Environmental Review Team Report

Gravel Excavation

Montville, Connecticut

October 1980

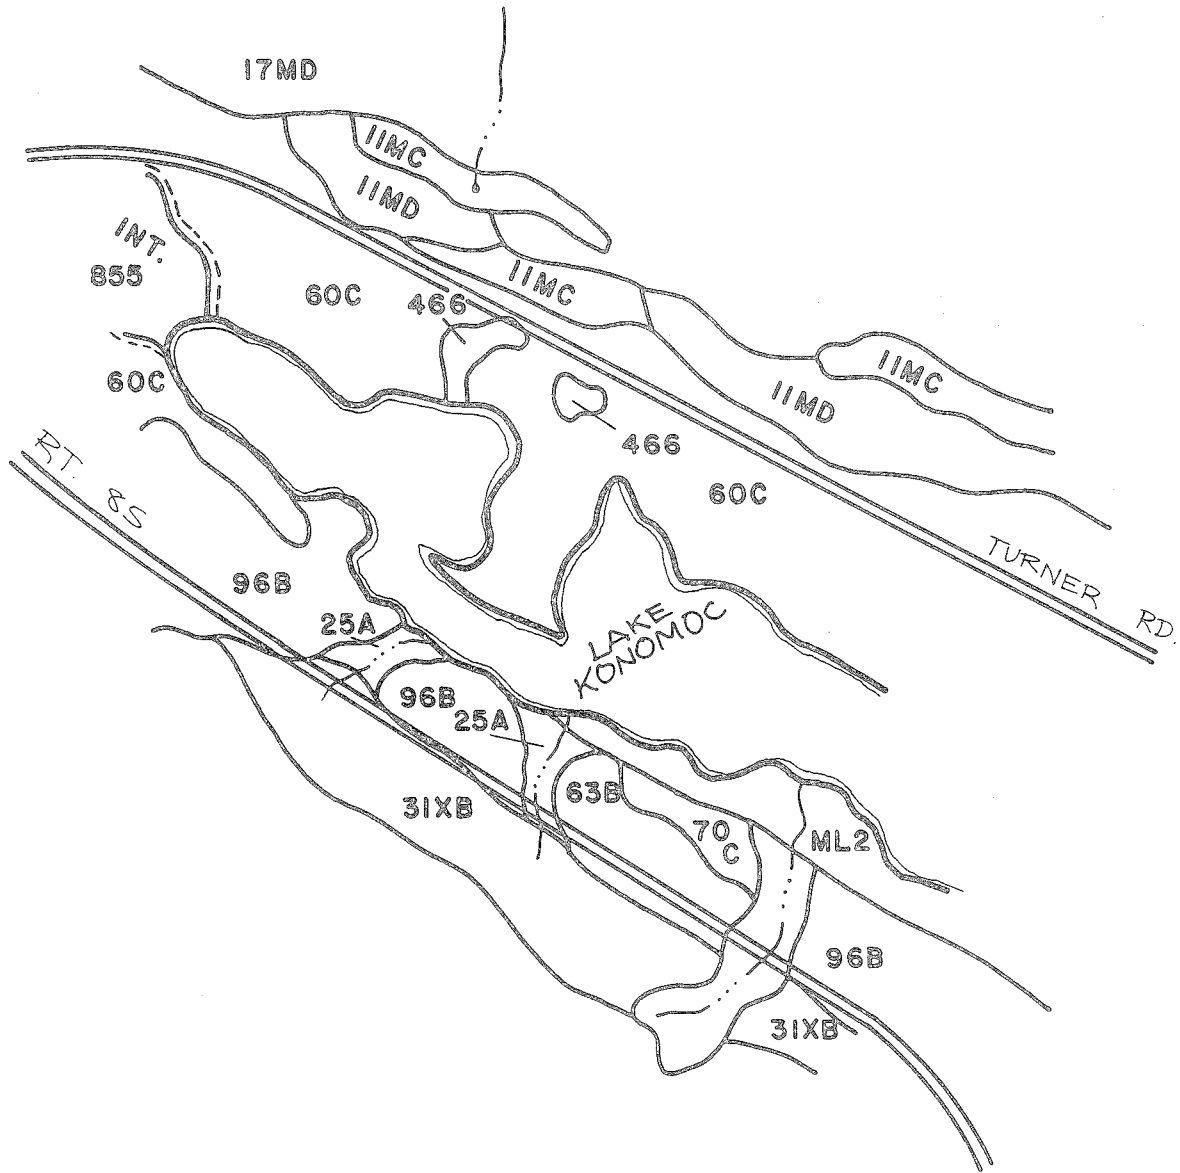
Planting a combination of eastern white pine, eastern hemlock and larch on elevations greater than 185 after excavation would be desirable.

Although the sawtimber has already been harvested from the majority of this tract, the sapling and pole size trees which remain should be utilized as fuel wood.

The mixed hardwood stand (vegetation type A) will still provide between 12 and 18 cords of fuelwood per acre, and the unharvested mixed hardwood stand (vegetation type B) will provide between 16 and 22 cords per acre.

As a result of the time schedule which has been set up by the City of New London, for clearing vegetation and excavation of this tract, it would be feasible to harvest some of the white spruce in the plantation (vegetation type C) for Christmas trees. Large white spruce could be topped and still provide quality Christmas trees.

The screening effect of the natural vegetation proposed to remain, approximately 70 to 100 feet wide along Turner Road, may be enhanced by an underplanting of eastern hemlock. These trees could be spaced from approximately 10 feet by 10 feet to 20 feet by 20 feet, depending on the completeness of screening desired.

It should be noted that the more sunlight which reaches these trees, the faster they will become an effective visual barrier. It may be desirable to remove approximately 1/3 of the trees which form the canopy in this area to assure that ample sunlight reaches the hemlock for fast growth. Only poor quality and damaged trees in the overstory should be removed from this area.

The proposed plan calls for Christmas tree planting on all areas where elevations are 185 feet and greater, above sea level. Unless Christmas trees are specifically desired for future sale, it might be desirable to plant a combination of eastern white pine, eastern hemlock and perhaps larch. These species may be planted in a random mix approximately 8 to 10 feet apart. They would be aesthetically appealing, help to reduce erosion and improve habitat for wildlife. In addition, they would not need as much maintenance as Christmas trees.
